**CULTURAL RESOURCES OFFICE
 PRESERVATION BOARD
 REGULAR MEETING
 MONDAY OCTOBER 27, 2014 — 4:00 P.M.
 1520 MARKET ST. #2000
 ST. LOUIS, MISSOURI 63103
www.stlouis-mo.gov/cultural-resources**

DATE: October 27, 2014
ADDRESS: 4167 McRee Avenue
ITEM: New construction of a single-family residence
JURISDICTION: North I-44 Certified Local Historic District — Ward 17
STAFF: Betsy Bradley, Cultural Resources Office

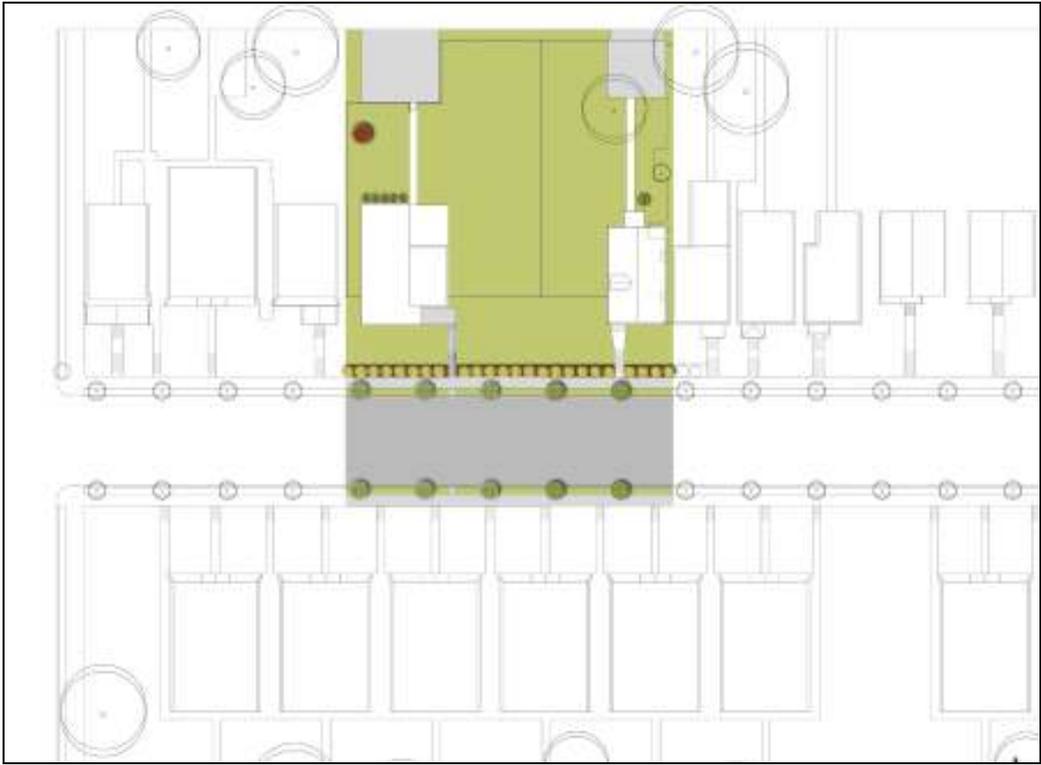
A wood privacy fence is proposed to enclose the side yard east of the house and to close the gangway west of the house.

EXISTING FRONT (NORTH) ELEVATION

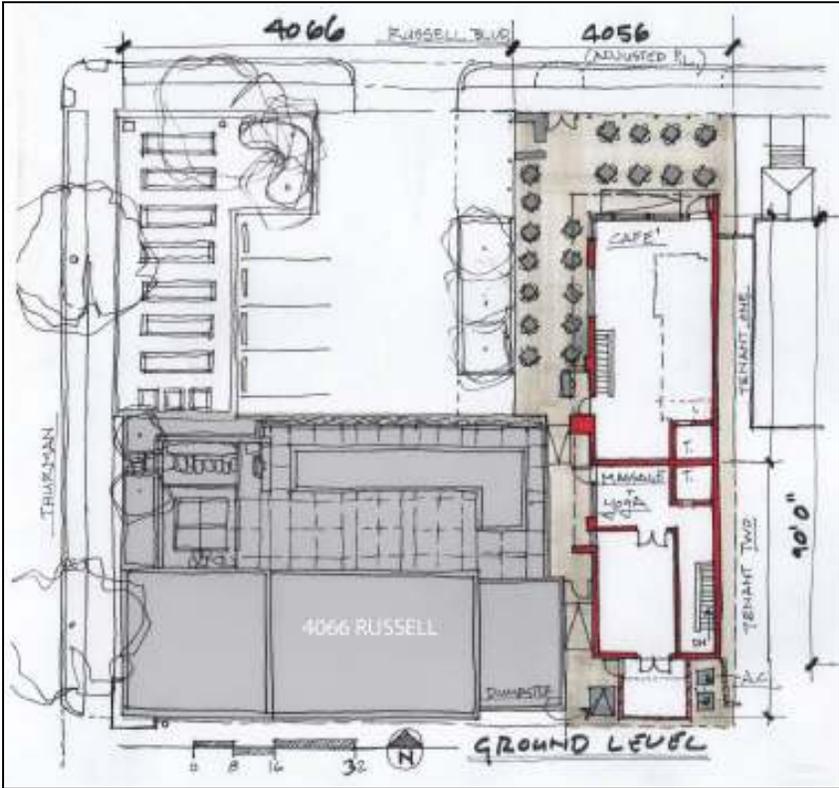
Partly complies. The exterior materials proposed will be similar to those previously approved by the Preservation Board for the rehabilitation of 4066 Russell. The majority of the building, currently concrete block, will be faced in smooth-finished stucco, a material which was used for front façades on buildings in the district, although the majority of those in the immediate vicinity of the site have brick fronts. Many of these have been painted in light colors and now present a uniform appearance that is similar to the proposed wall treatment. Trim for panel insets is proposed to be a horizontal cement board siding that, while not lap siding, does reflect a traditional material used for bays, porches and other secondary elements on historic buildings. The building currently has a deteriorated metal fascia and coping set at the front and side parapets. On the new design, a metal projecting cornice will extend across the front façade and return along the western elevation.

Partly complies. While the proposed details are strongly contemporary in character, they reference materials and some details present in the district's historic buildings, such as the open front porch at the main entry, a raised front parapet, and projecting cornices.

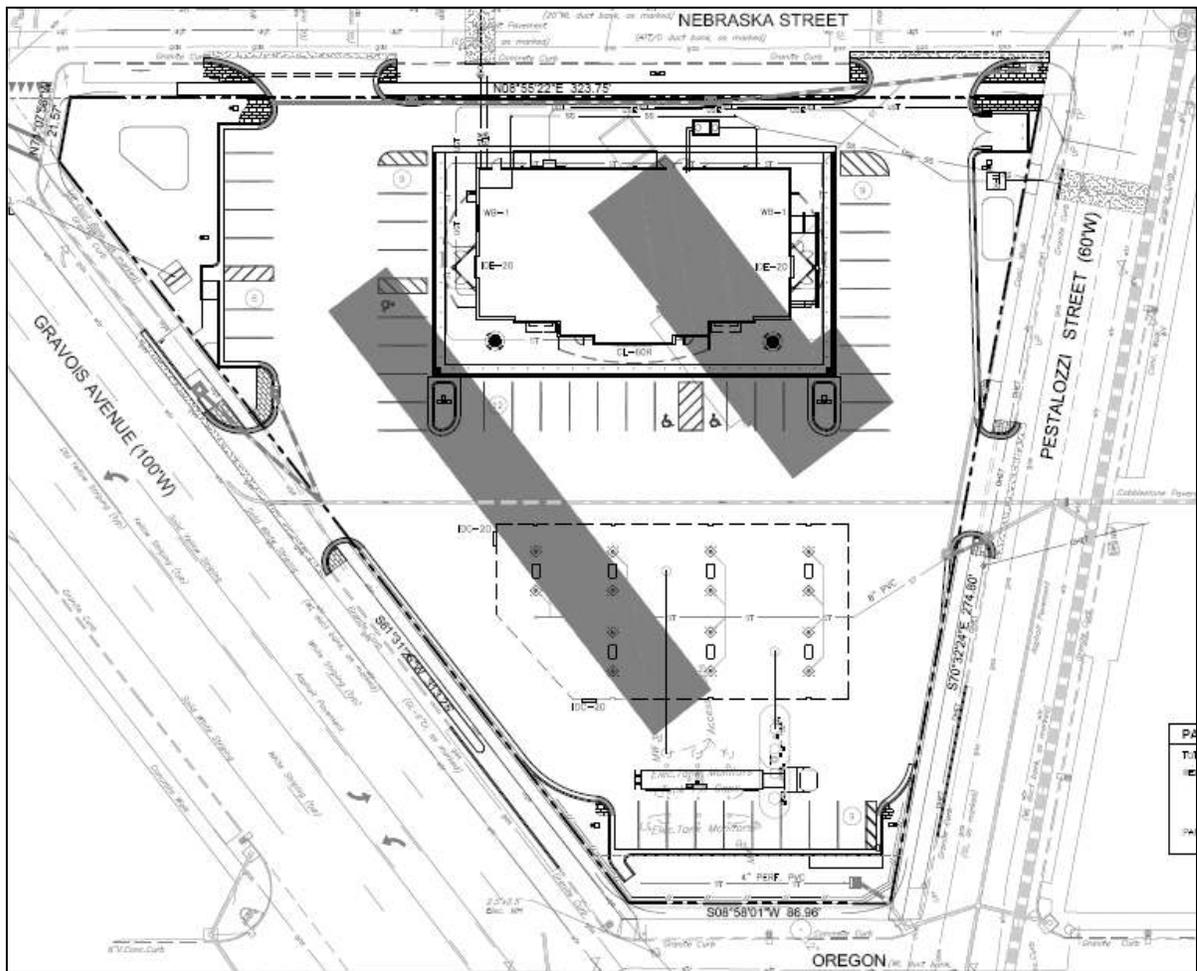
Does not comply: The owner is working with Cultural Resources Office staff to redesign the retaining wall to be of cast stone, have a vertical plane, and a cap so that the wall is closer to meeting the intent of the standard.

FLOOR PLAN SHOWING FIELD HOUSE, BRIDGE AND ADDITION

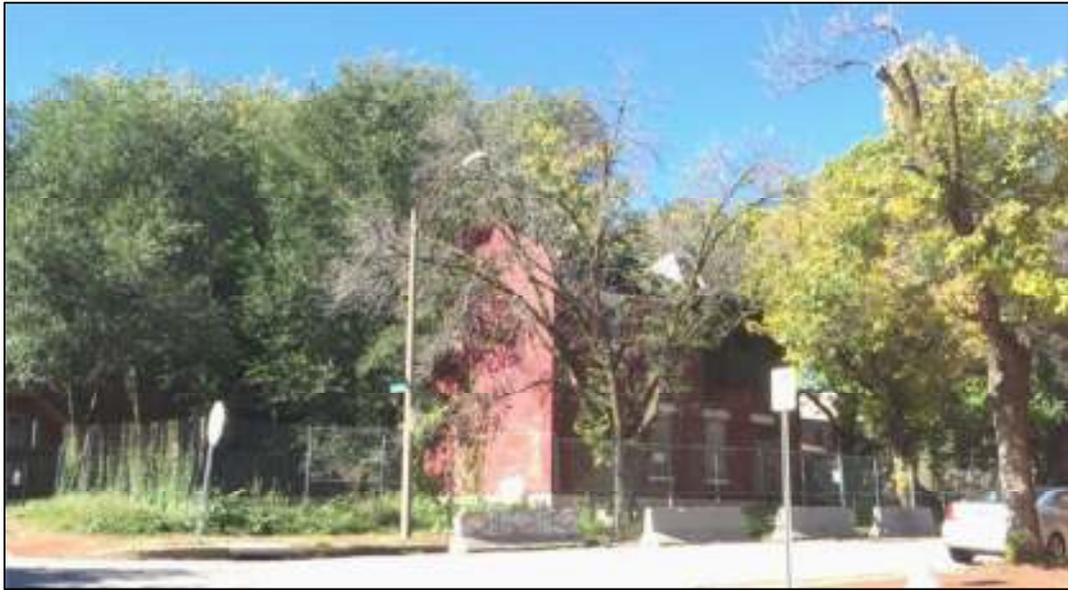
- The connecting bridge is raised above the grade of the yard to meet the main floor level and is set back from the street façade. The glazed passageway is minimal in presence and an appropriate means to connect the addition to the rowhouse while leaving the volume and form of the rowhouse unaltered.
- The need to convert one window created in the north wall during the 1930s to a door for access from the bridge is a minimal change in an already altered portion of the Landmark. The impact on a portion of the brick wall is also acceptable in the effort to afford accessibility to the main floor of the Field House.
- The design of the museum addition relates to and complements the Eugene Field House and establishes an appropriate physical context for the Landmark.

GARAGE DOOR ON ADDITION THAT FACES RUTGER

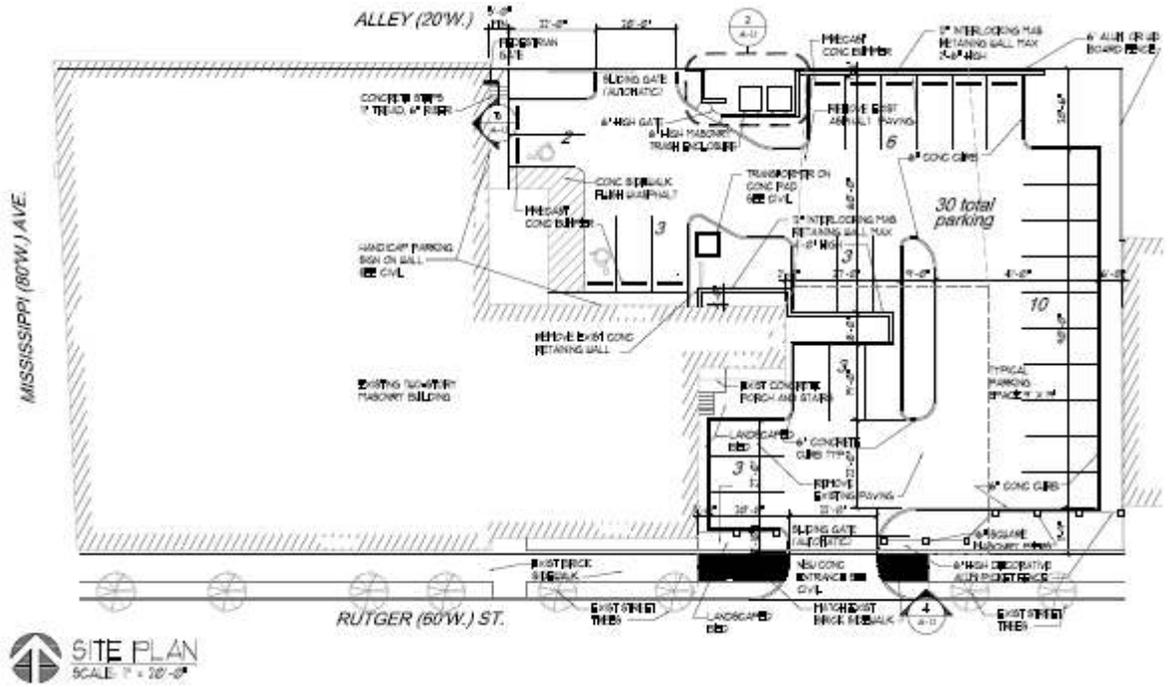
- 1917 Rutger is located in the Lafayette Square Local Historic District.
- The method proposed for window infill on the Private Façade does not meet the requirements for the Lafayette Square Historic District.
- The infilled doors and windows on the alley are considered to be on a Secondary Public façade, as the building is adjacent to an alley and the alley façade is visible from public areas. Both the man and vehicular doors require an Historic Model Example as the basis for any replacement of the doors.
- The garage doors being replaced with windows on the Public Facades do not meet the requirements for Vehicular Doors.
